VALUE ENGINEERING STUDY

Project # STP00-0198-01(020) PI No. 132610-

SR60 Widening & Reconstruction in Murrayville
Hall County, Georgia

23 June 2011

R-1.0 Existing Sketch with Bridge

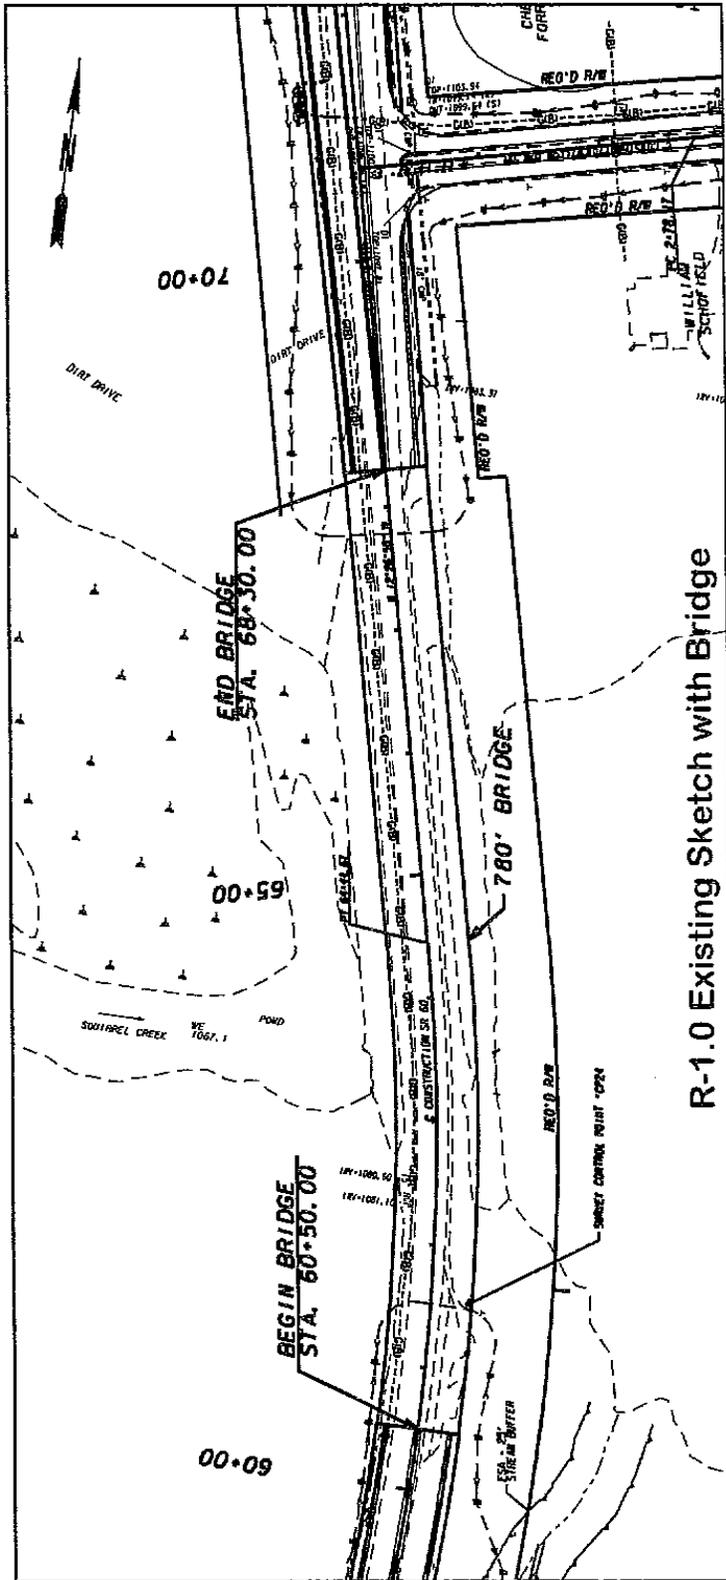
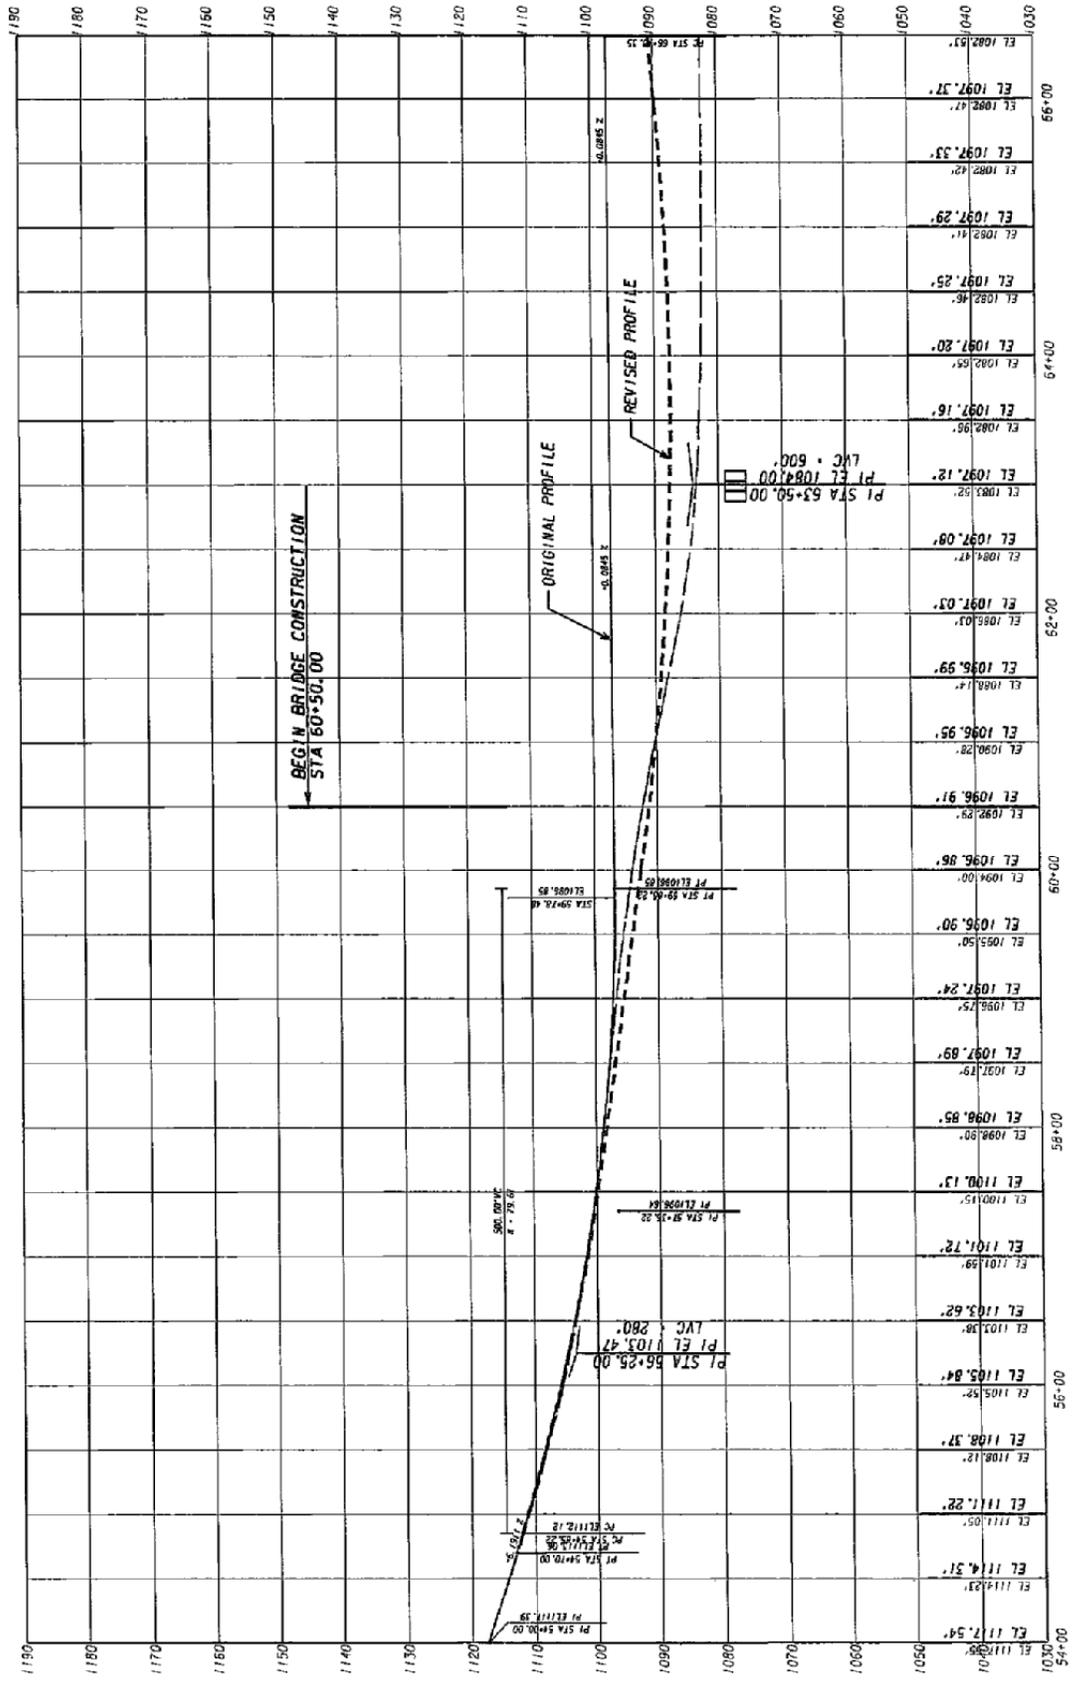
ORIGINAL DESIGN: The current design for SR60 includes a new 4-lane bridge with a 6' median from Sta. 60+50 to Sta. 68+30, a length of 780 feet (cover sheet and profile sheets show different bridge stations). Proposed profile in area of bridge is raised to approximate elevation of 1097.3' to allow 1' of freeboard between structure (depth of structure is unknown) and flood elevation of 1085' (elevation of flood provided by design consultant). Existing roadway is approximate elevation of 1082.5'.

PROPOSED CHANGE: The proposed recommendation is to eliminate the new bridge over Squirrel Creek and widen SR60 on fill by extending the existing triple 10' x 9' culvert. Adjust the proposed profile of SR60 to keep the roadway subgrade 1' above the flood elevation of 1085'. Impacts to stream buffer may result in the need for a Practical Alternatives Report (PAR).

JUSTIFICATION: Construction time can be shortened 12 to 18 months by not having to build a 780' structure in two stages to maintain traffic. Construction cost will be reduced.

R-2.0 Plan View 1 of 3

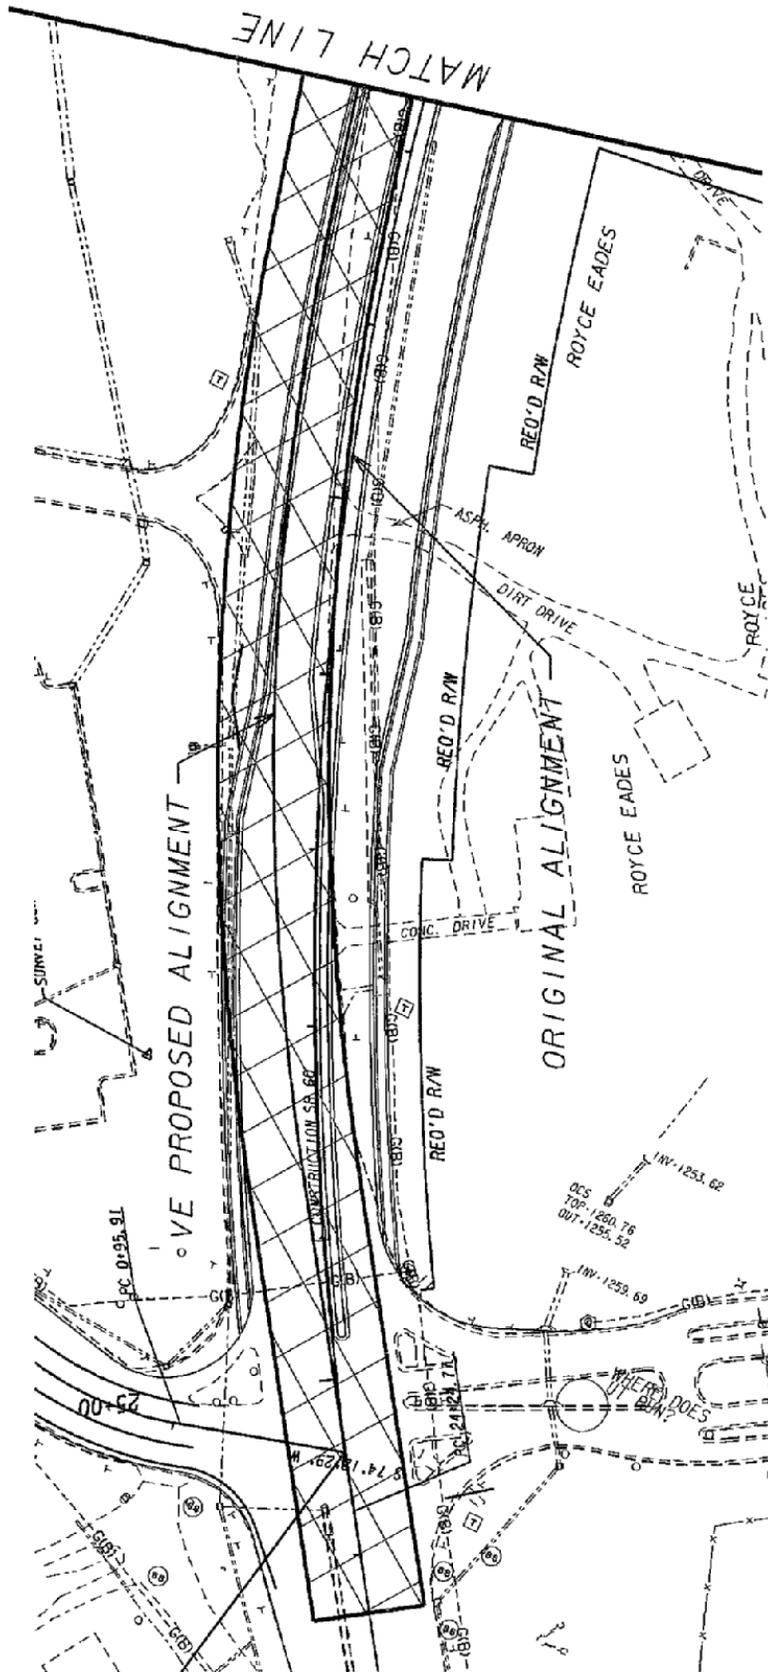
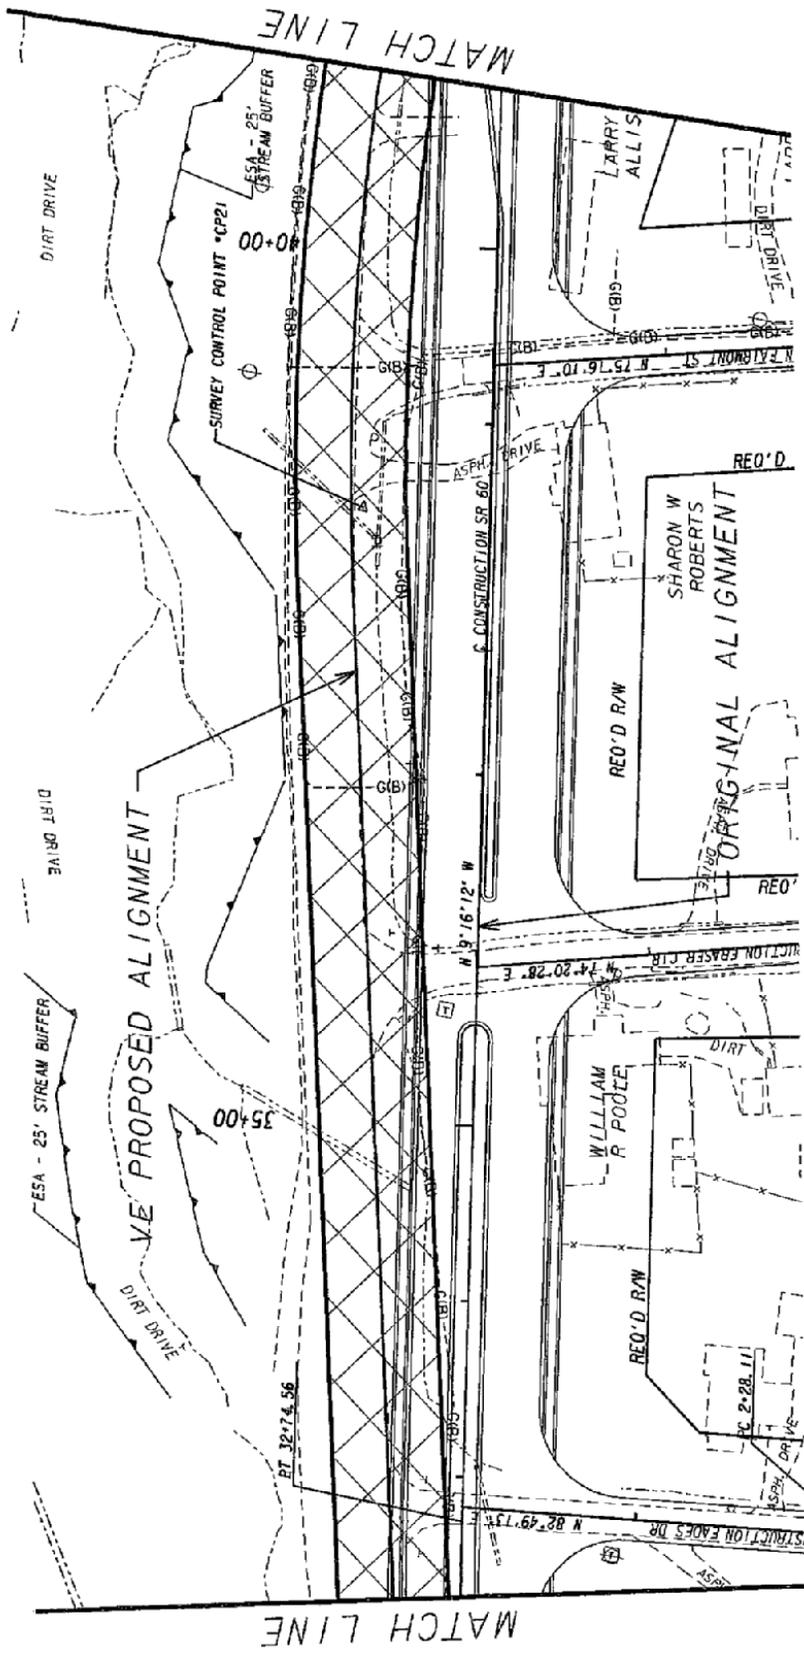
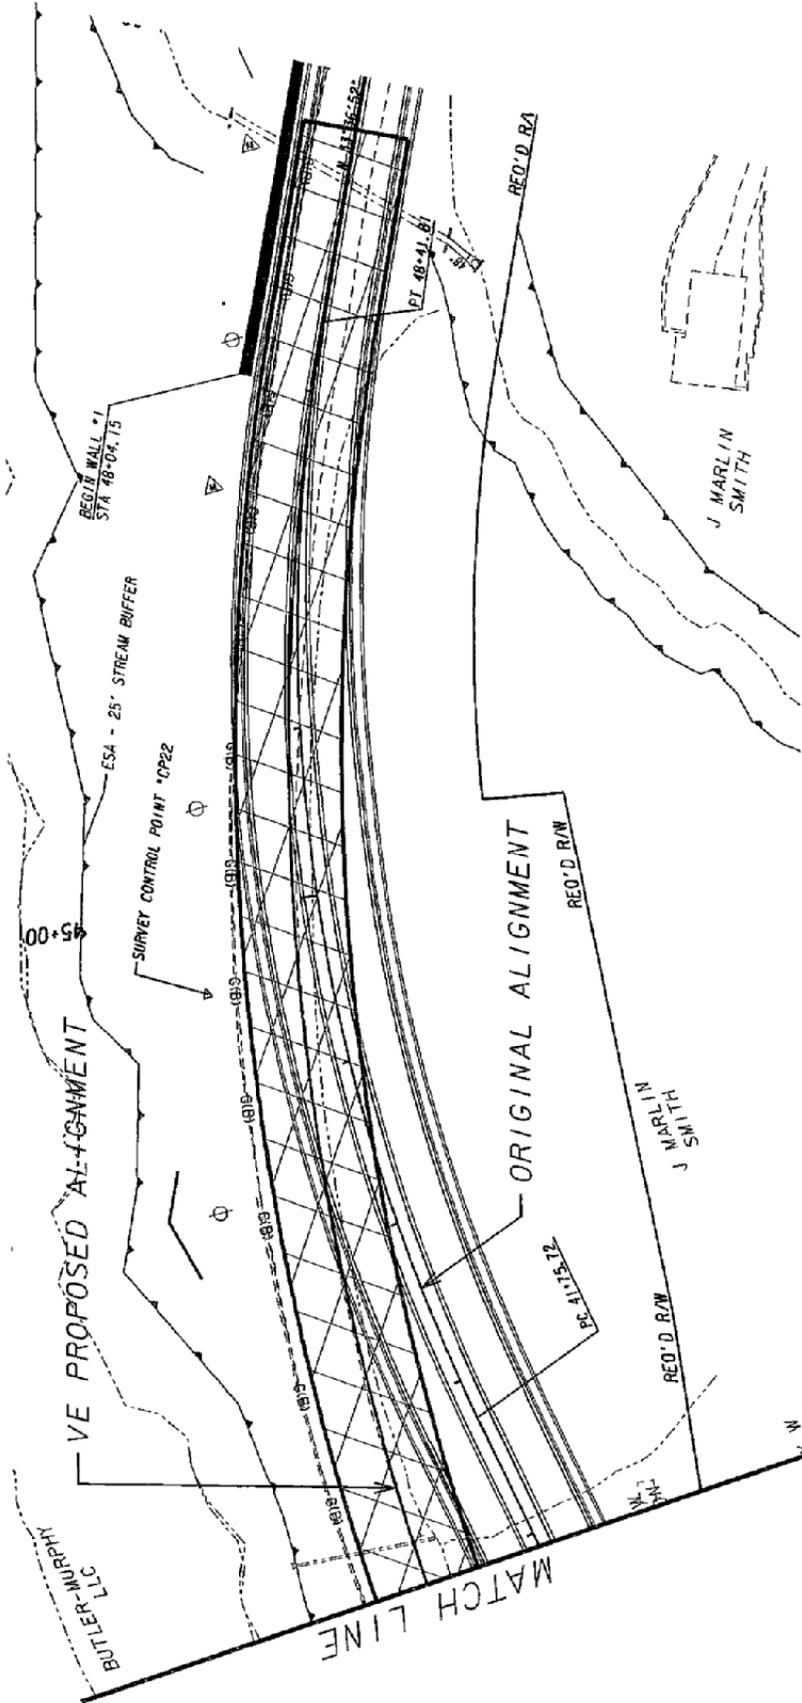
ORIGINAL DESIGN: In the current the design the horizontal alignment of SR60 is shifted to the East beginning at Sta 28+00 and ending at Sta 48+00. At the approximate midpoint of the shift, the proposed centerline is 100' +/- east of the original centerline. The vertical grade from the PVI Sta. 27+80 to PVI Sta. 34+60 is proposed at 7.00%. The existing roadway is approximately 9%. Three side roads tie into SR60 within this section (Eades Dr., Fraser Cir., Fairmont St). The proposed roadway is being raised as much as 25 feet above the existing roadway. Five residential displacements are indicated as a result of this horizontal and vertical alignment. Approximately 20 parcels are impacted by ROW acquisition in this station range.

PROPOSED CHANGE: The proposed recommendation is to revise the horizontal and vertical alignments from Sta. 28+00 to Sta. 48+00 to keep the two southbound lanes of SR60 at the current horizontal and vertical location of the existing SR60 travel lanes. The proposed vertical grade will be 9.000% and a design exception will be required.

R-3.0 Proposed Change Sketch 1 of 1

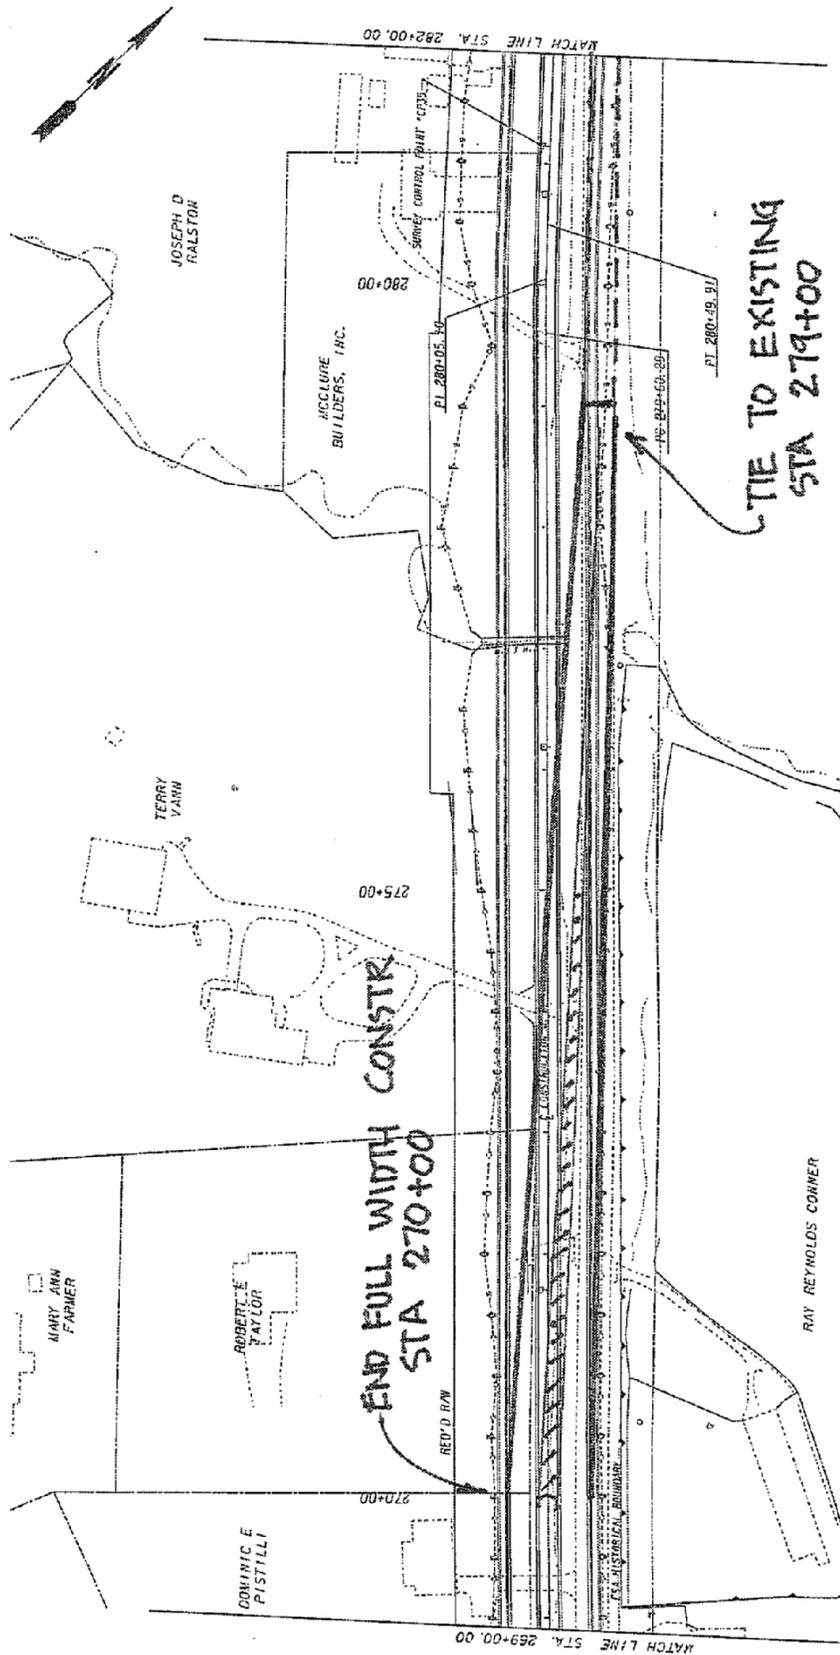
PROPOSED CHANGE: It is proposed to end full width construction at Sta. 270+00 in lieu of Sta. 284+00 and taper to the existing by Sta. 279+00 in lieu of Sta. 297+50.
